LOT GRADING PLANS APPROVED SUBJECT TO REVISION'S NOTED

PROJECT/LOCATION **OLDE WINCHESTER** BROOKLIN, ONT

SITE GRADING PLAN

LOT NUMBER 135

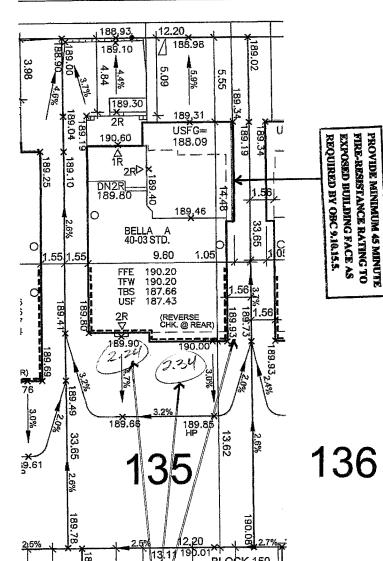
BH-24-6" -7.52+0.9d = 8.46

USE SK-1 DETAIL FOR FOUNDATION WALLS ON THIS LOT (SEE ATTACHED)
